The Countryside Agency lessons learnt review of the mapping of open country and registered common land

Response by the British Mountaineering Council

- **Castle Naze, Nr. Chapel en le Frith.**

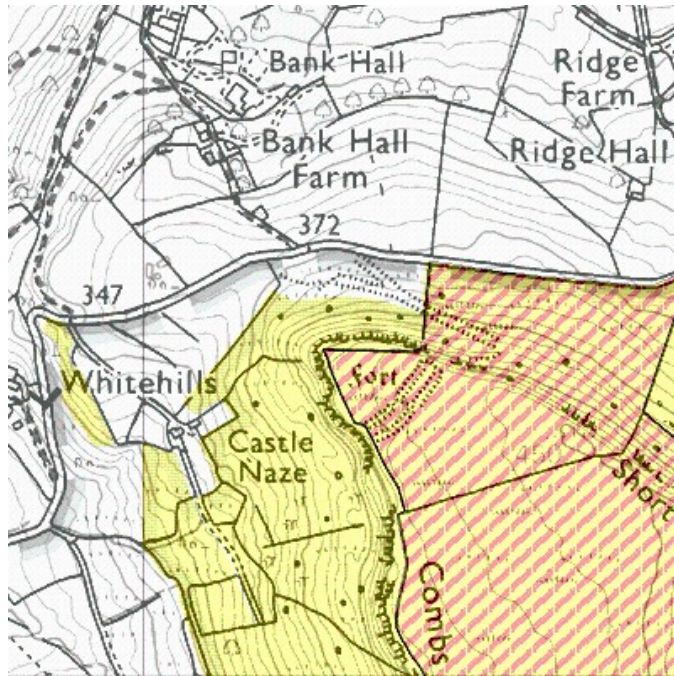
Crag not served by PRow , Non CRoW land between crag and highway requires re-mapping.

- **Wolf Edge, Nr. Flash.**

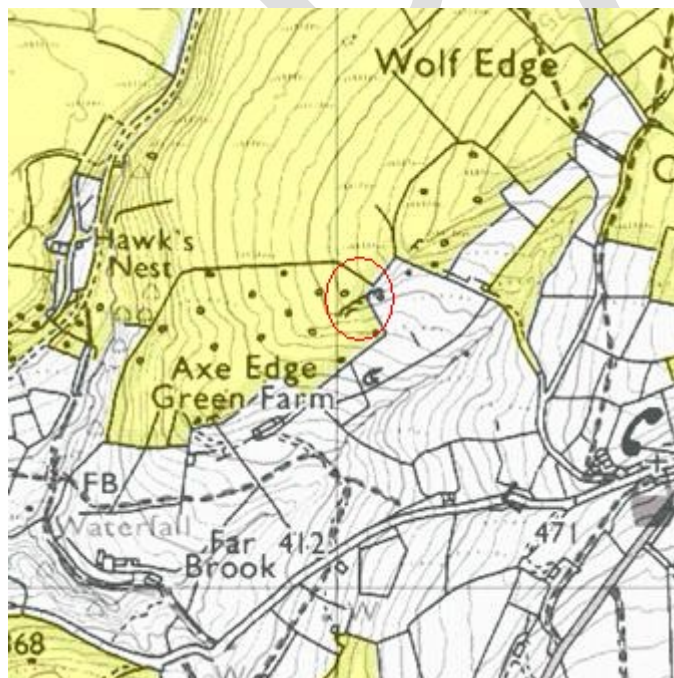
Crag and boulders not served by PRow, proportion of the crag mapped as CRoW land, crag not directly accessible on CRoW land - requires remapping.

- **The Roaches Skyline, Roaches Estate**

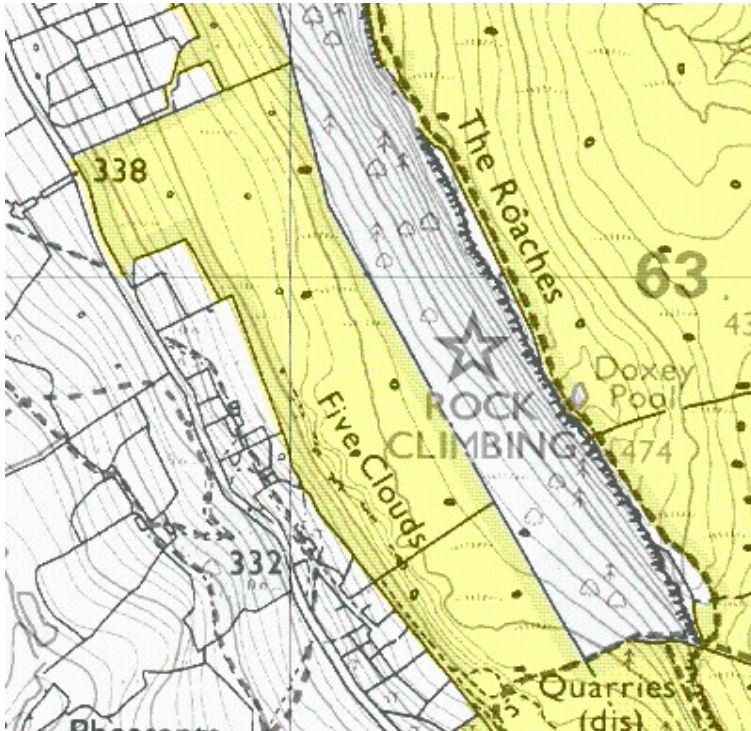
Mapping anomaly. The main Upper and Lower Tier crags were mapped as CRoW land, but the Skyline crags are not – requires remapping.

- **Nth Cloud, Roaches Estate.**

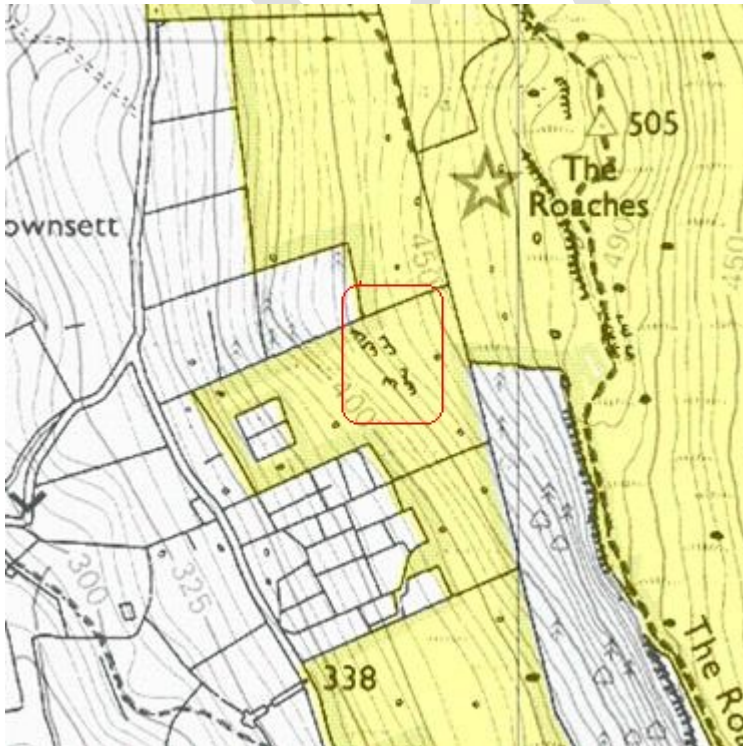
Although crag and boulders are situated on CRoW land, the crag is not served by a PRoW and remains isolated from the highway – surrounding land requires reassessment.

- **Hanging Stone Rock, Danebridge.**

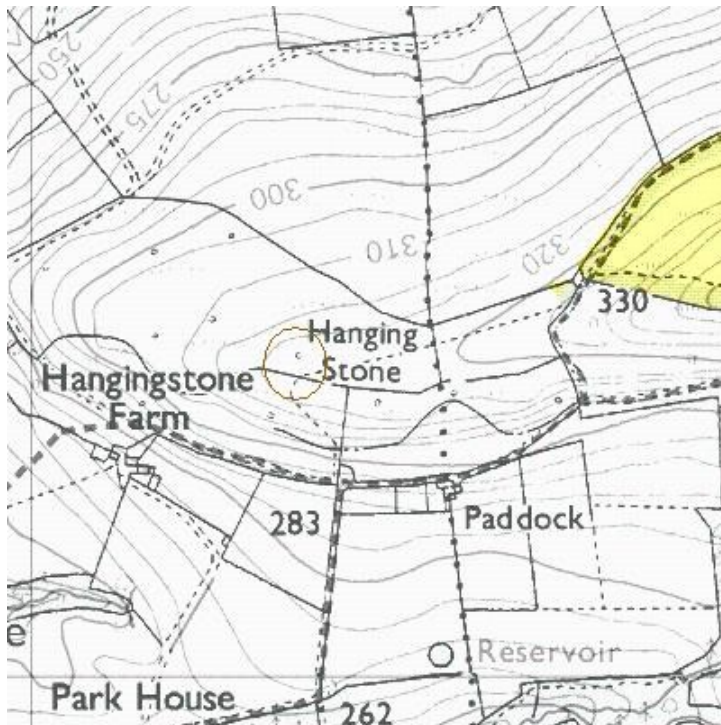
Site situated in proximity to mapped CRoW land and displays a numbers of qualifying criteria – requires mapping.

- **Lawrencefield (Bolehill Quarry), Nr. Hathersage.**

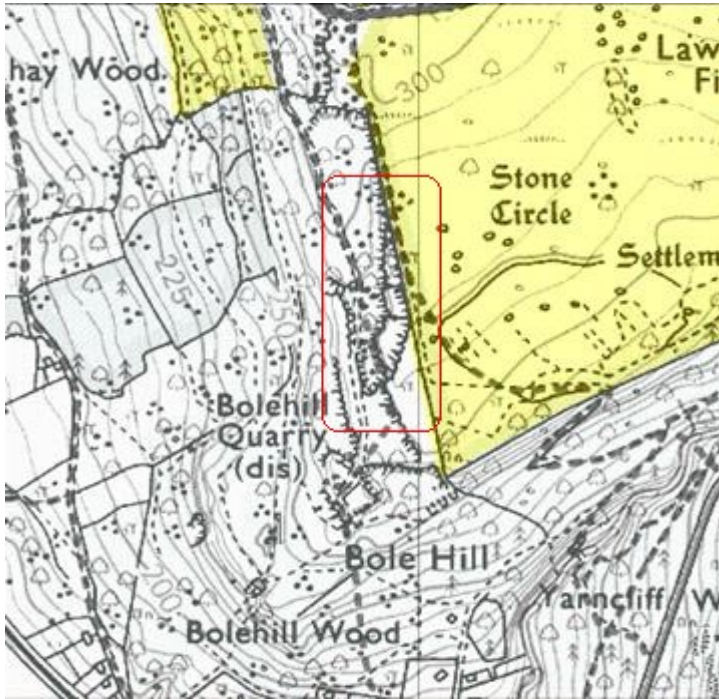
The crag is served by a PRow but demonstrates a number of qualifying criteria – requires mapping.

- **Froggat & Curbar Edges, Nr. Baslow.**

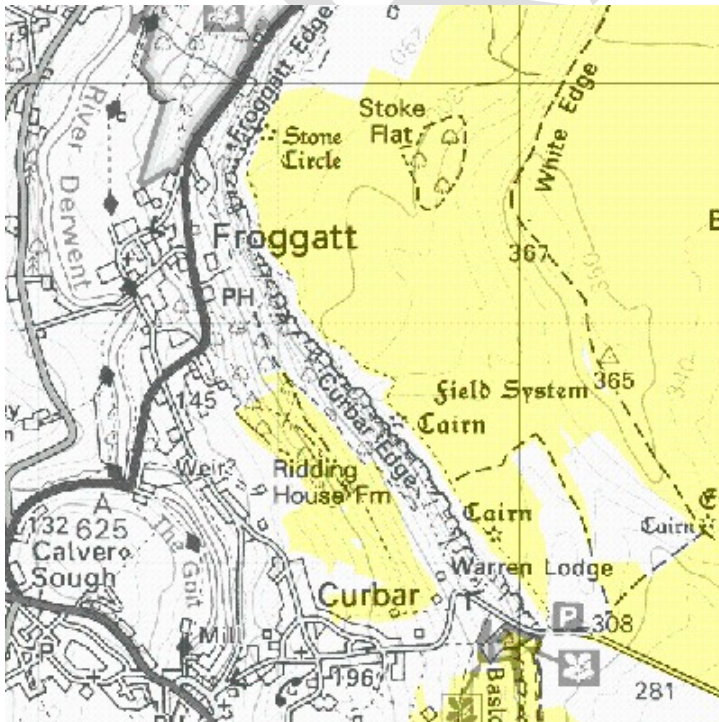
A significant mistake. The edges are served by a PRow above, but the length of the Froggat & Curbar escarpment has not been mapped as CRoW land. The mapping boundary appears to have been drawn at a fence line (parish boundary?) above the edges – requires remapping.

- **Birchen & Gardoms Edges, Nr. Baslow.**

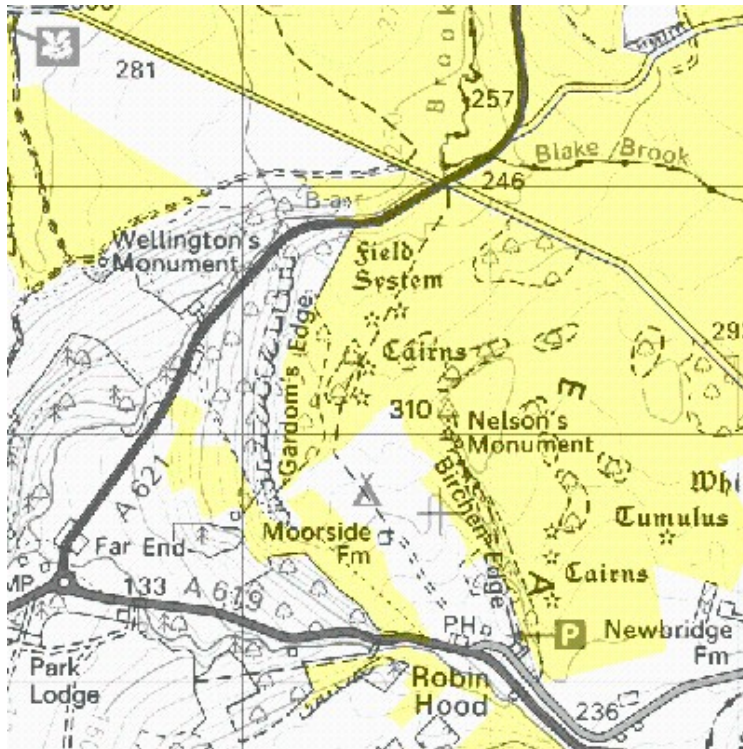
Inconsistent mapping – both crags are very similar in character, but Gardoms has not been mapped as CRoW land and is not served by a PRoW – requires reassessment.

- **Beeston Tor, Nr. Wetton.**

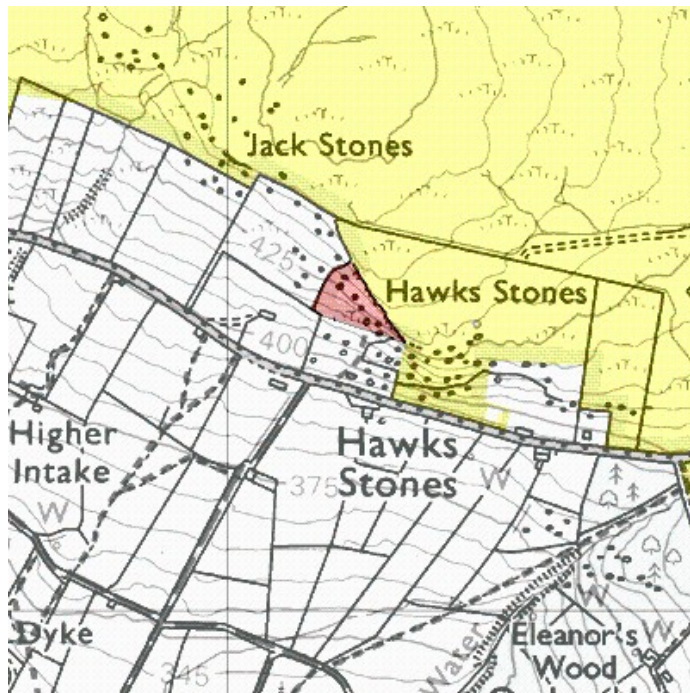
Fulfils a number of qualifying criteria, proximal local areas with similar characteristics have been mapped as CRoW land – site requires mapping.

▪ Castle Quarry, Todmorden.

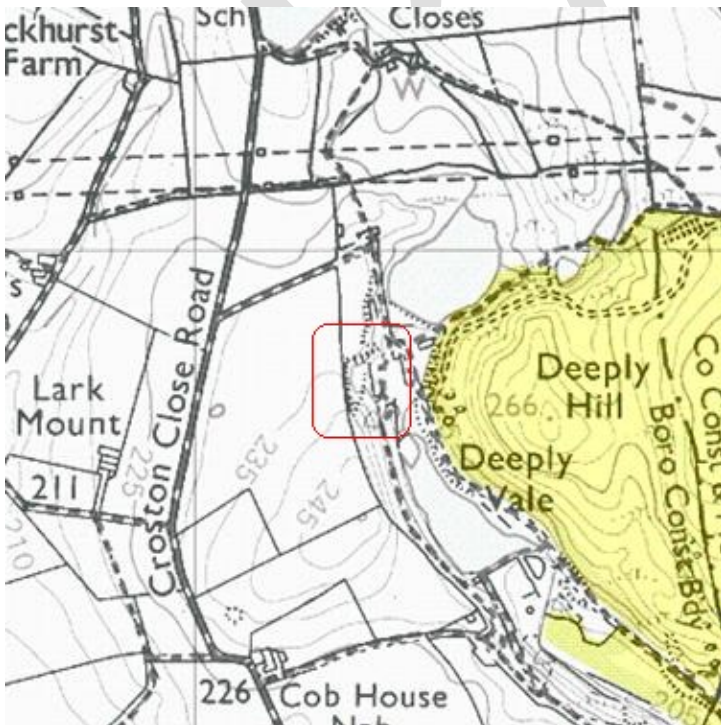
Natural England have acknowledged this mistake. The intention was to include the site on the definitive map but an administrative error occurred – requires remapping.

- **Malham Cove**

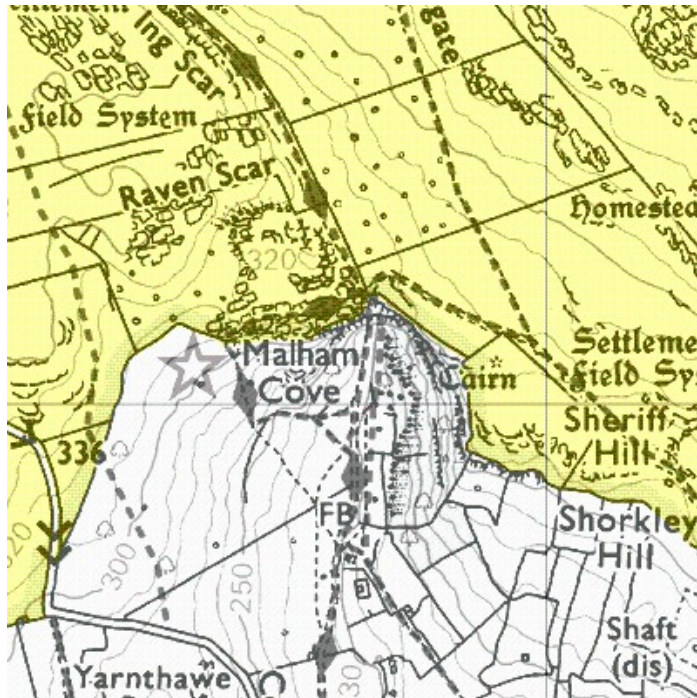
Located on a PRoW but cliff faces and land immediately below are not CRoW access land – requires mapping.

- **Blue Scar, Littondale, N. Yorks**

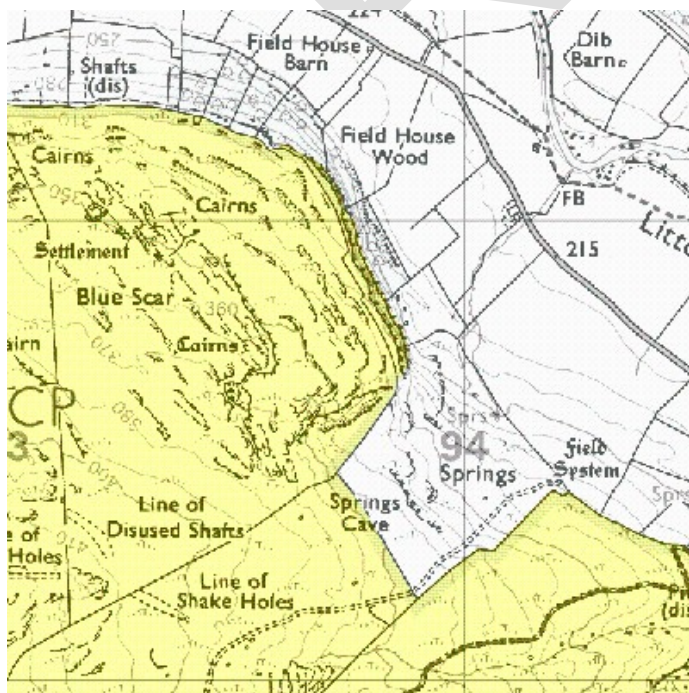
Crag face used as CRoW boundary – crag not served by a PRoW, land parcel below (NE) crag is qualifying habitat - requires remapping.

- **Raven Scar, Chapel le Dale, Ingleton.**

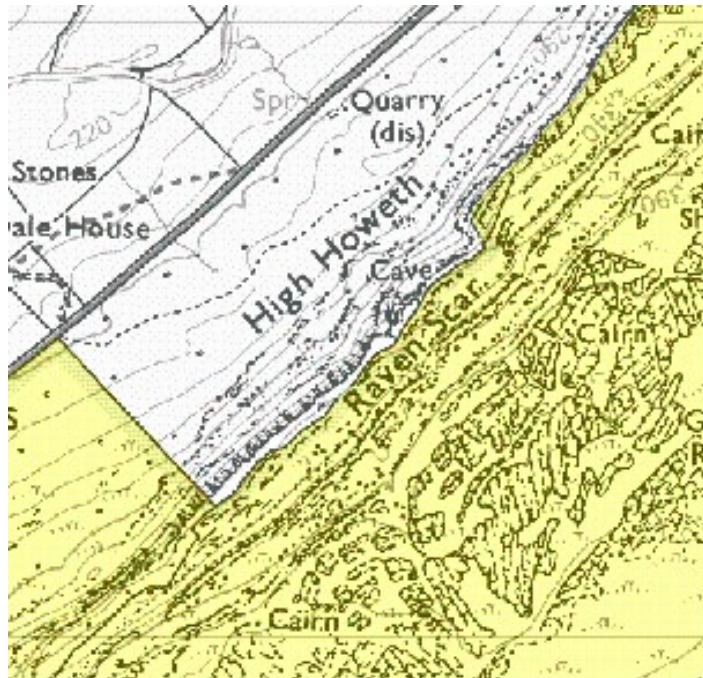
Inconsistent mapping. Parts of the escarpment have been mapped as CRoW land while other sections have not - despite being composed of qualifying habitat.

- **Giggleswick Scars, Nr. Settle.**

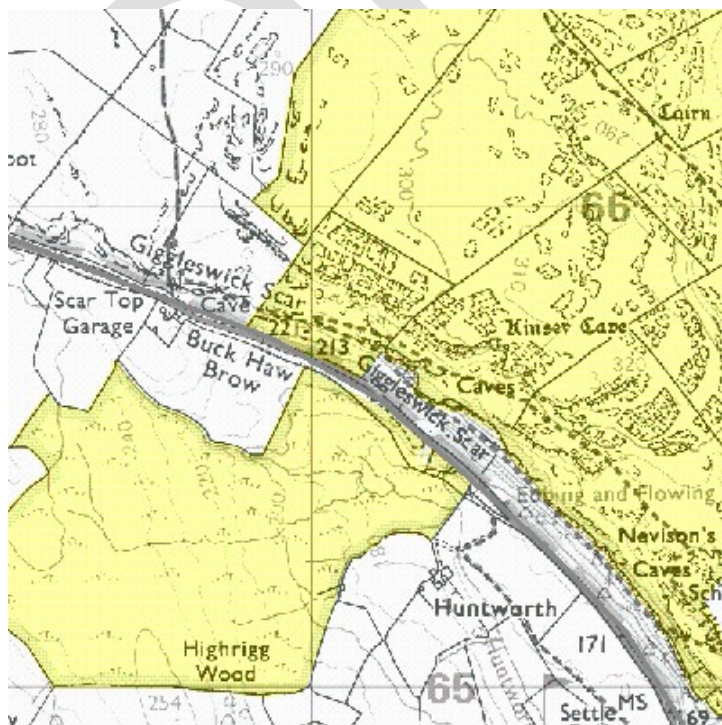
Northern crag not mapped as CRoW land, Southern crag cliff face used as CRoW boundary – requires remapping.

- **Foredale (Arcow) Quarry, Nr. Helwith Bridge.**

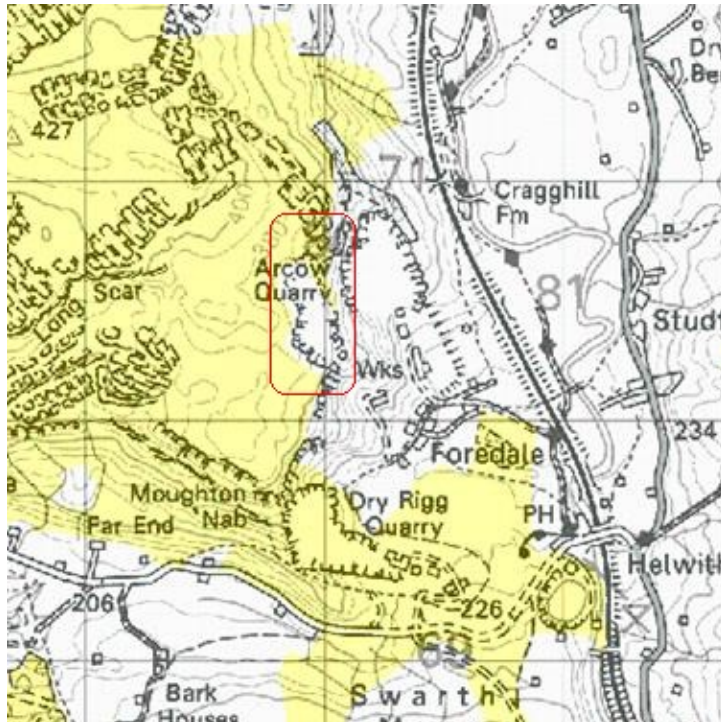
Inconsistent mapping – Foredale quarry not included as CRoW land, but other proximal sites were mapped – requires reassessment.

- **Beggar's Stile & Moughton Scars, Nr. Austwick.**

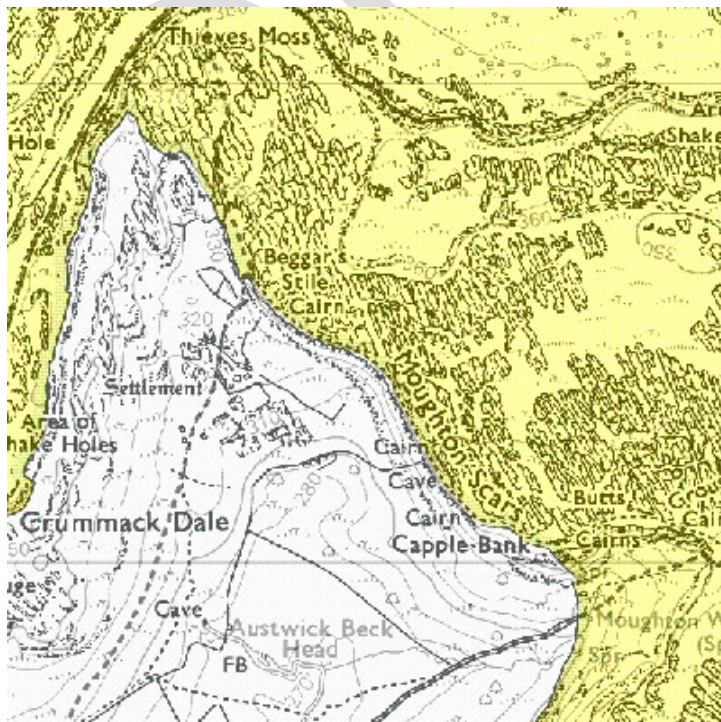
The crags are served by a PRoW, but the crag faces (and land below) is not mapped as CRoW land – require remapping.

- **Rylstone, Barden Moor, Nr. Rylstone village.**

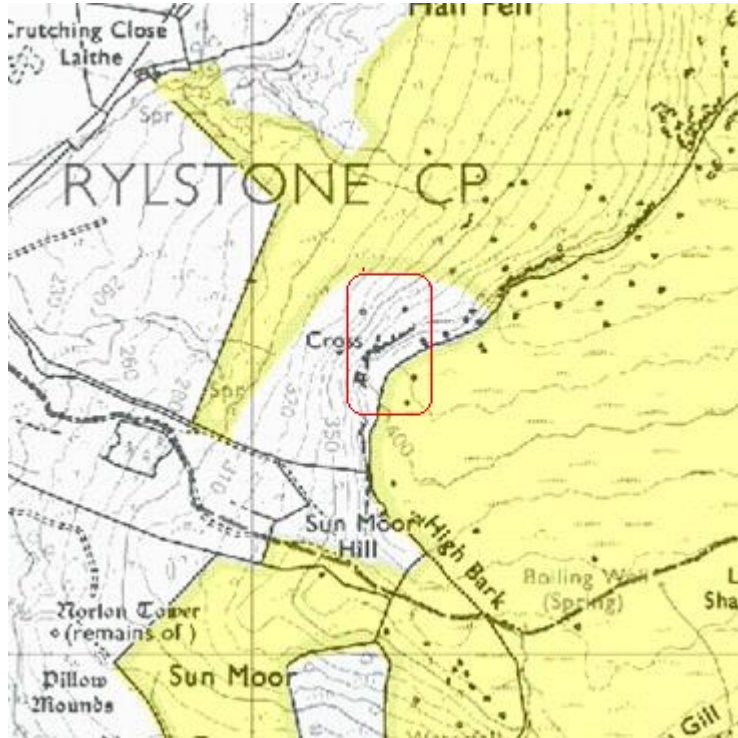
Inaccurate mapping. In this location the CRoW boundary is been located along the Civil Parish or Community boundary - excluding the main buttress. The remainder of the escarpment is mapped - requires remapping.

- **Eastby Crag, Eastby, Nr. Skipton.**

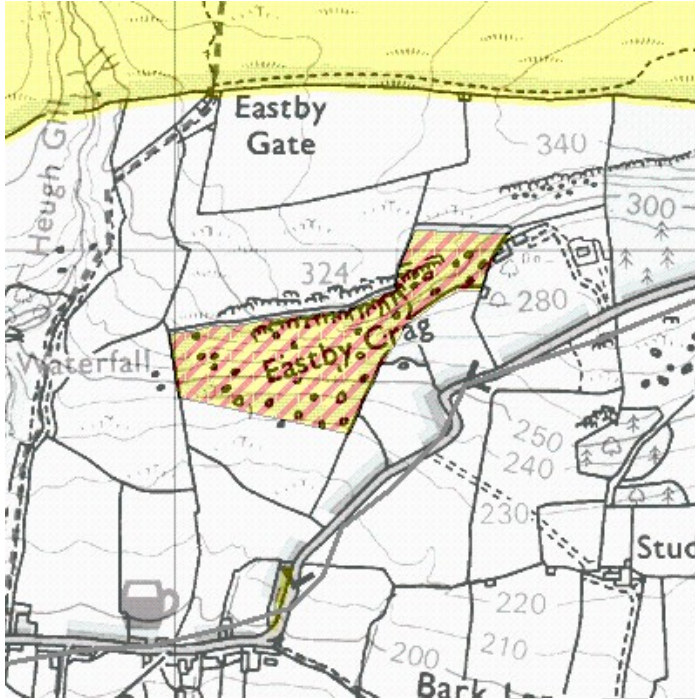
Unusual case of an ‘island’ of CRoW land containing the crag - not served by a PRoW and surrounded on all sides by land with no right of access.

Access to the crag is facilitated by agreement between the YDNPA and tenant farmer. Upper tier boulders are qualifying habitat and require remapping, and the surrounding land requires reassessment.

- **Orgate Scar, Nr. Richmond.**

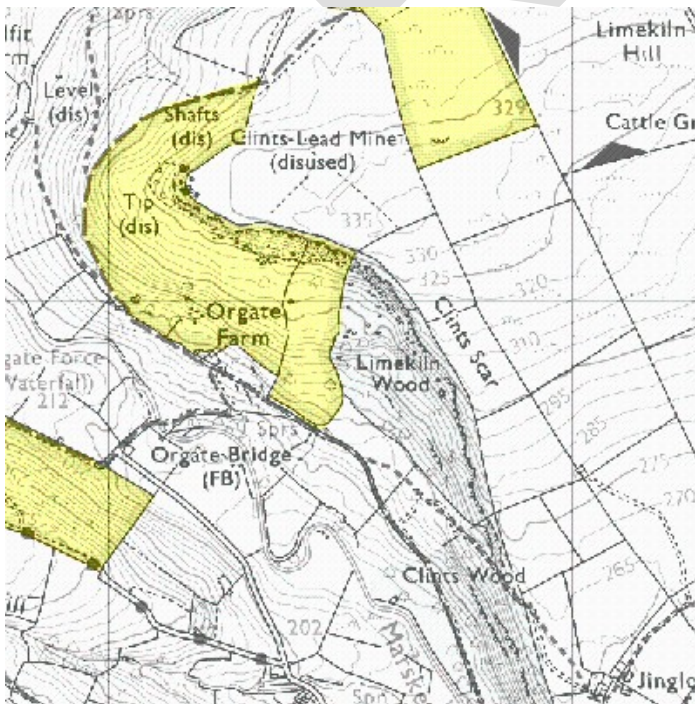
Half the crag is mapped as CRoW land, the remainder is not. Crag is not served by a PRoW – requires remapping.

- **Highcliff Nab, Nr. Guisborough.**

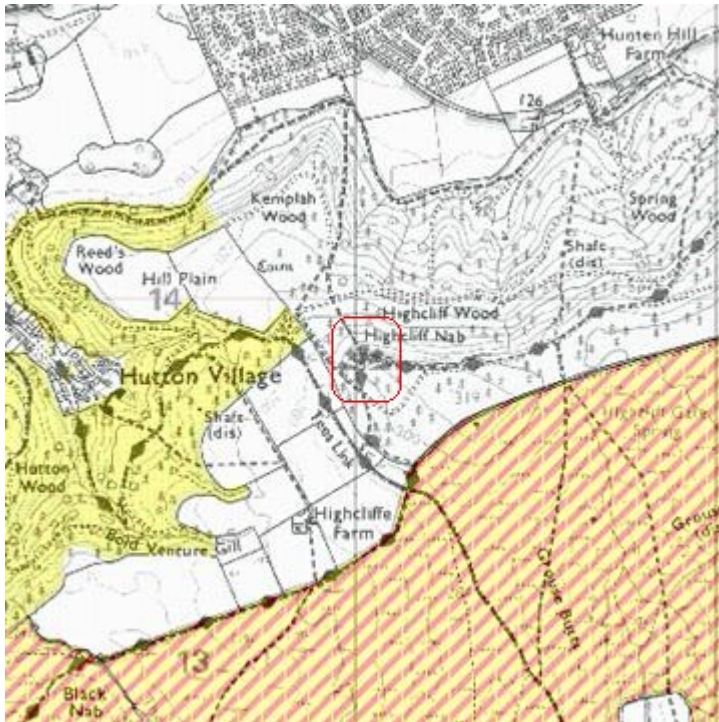
Crags is located close to CRoW land and displays a number of qualifying criteria – requires remapping.

- **Applegarth Scar, Nr. Richmond.**

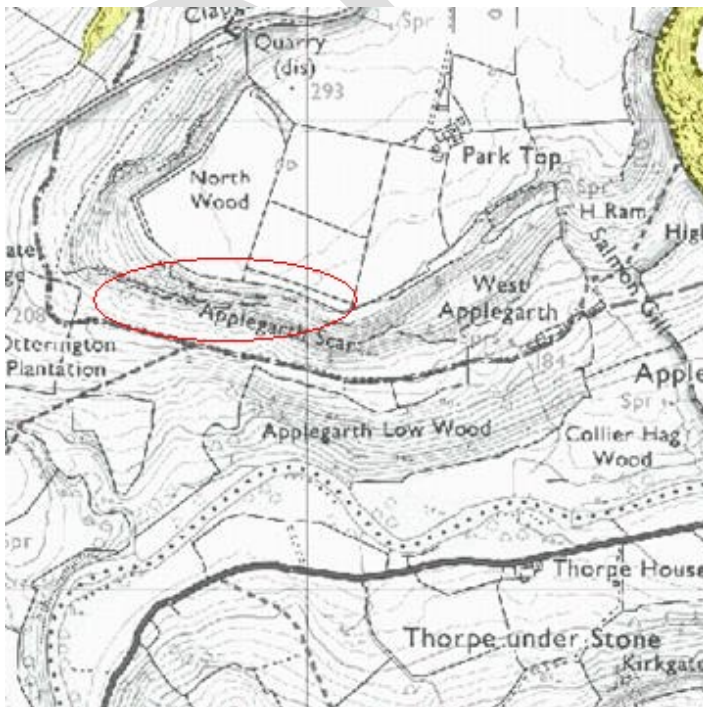
Site demonstrates a number of qualifying criteria, other proximal escarpments of the same character were mapped as CRoW land. Site requires mapping.
